PREPARED FOR THE PLAN COMMISSION AND URBAN DESIGN COMMISSION

Project Address: 4103-4119 Portage Road (17th Aldermanic District, Alder Clausius)
Application Type: Rezoning, Demolition, and Conditional Use
Legistar File ID #: [37648](#), [37370](#)
Prepared By: Heather Stouder, AICP, Planning Division
Report Includes Comments from other City Agencies, as noted

Requested Action: Approval of a rezoning from Temporary Agriculture to the Suburban Residential – Varied 2 (SR-V2) district, demolition of a single-family home, and a conditional use for a 284-unit multi-family residential complex.

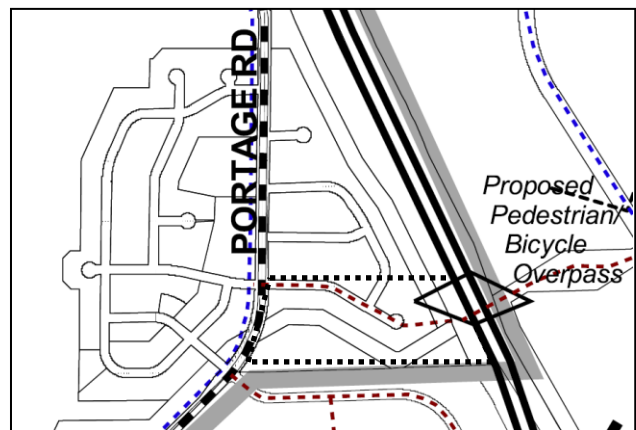
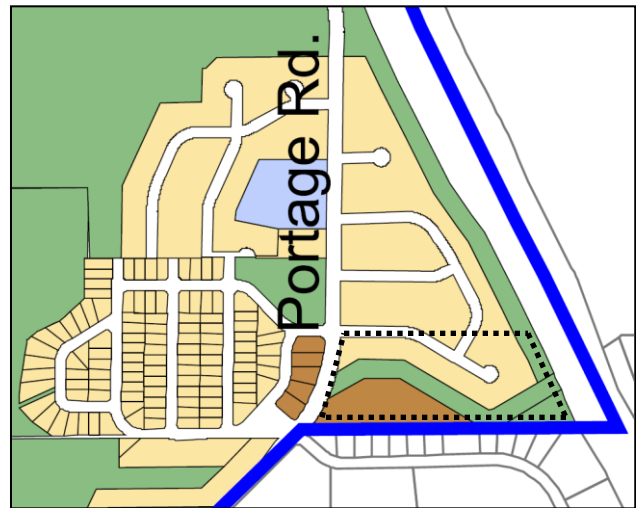
The Hanson Road Neighborhood Development Plan (last adopted in 2000) recommends Low-Density Residential (defined differently in this Plan as <8 dwelling units per acre) uses for portions of this property north of the creek, and medium density residential uses (defined in the Plan as 12-16 dwelling units per acre) for a small portion of the subject property south of the creek. On average, the subject site is recommended for approximately 10-12 dwelling units per acre. (See the subject property within the dashed line on the map excerpt at right.)

The Hanson Road NDP also recommends a bicycle/pedestrian overpass to link this property to the American Center, over I-39 (see map excerpt at right). Recently, staff has been made aware that this connection would more than likely be a tunnel under the interstate done in conjunction with a major WisDOT project. While not programmed at this time, staff anticipates that it could occur within the next 15 years. The applicant has agreed to provide an easement for this planned connection as part of the CSM associated with this request.

The proposed development is roughly twice the density as what is recommended in the Hanson Road Plan, but consistent with the Comprehensive Plan, which was adopted several years later. During the review process, staff stressed that the proposed density could only be supported if the site layout provided a strong orientation to the street, and supported future street connections to the north, where lower-density residential uses in a variety of housing types (small multi-family buildings, townhouses, and single-family homes) can be supported. In early discussions, the applicant presented conceptual street layouts north of this property that could be facilitated at some point in the future, and staff is assured that the proposed development supports, rather than precludes, the lower-density residential development recommended to the north.
